Title		[PD1-2] - MCU Breakout	
Size:	A4	Number:	1
Date:	01-Oct-18	Time:	9:46:19 PM
File:	C:\Users\lhami\Dropbox\University\Capstone\Hardware\PCB\PD1-2\MCU Breakout\PD1-2 - MCU.SchDoc	Sheet	1 of 1
Revision:		A	
*		*	
*		*	
*		*

ISCP CONNECTOR

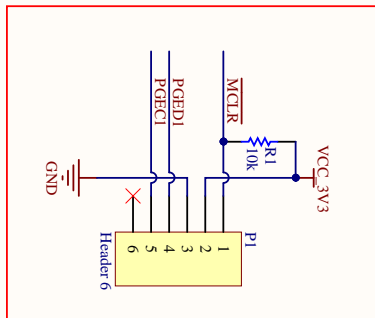
During programming and debugging it is recommended that the capacitor be isolated from the MCLR pin. Change this to a push button. Any one of the PGCCx/PGDX pins can be used for programming.
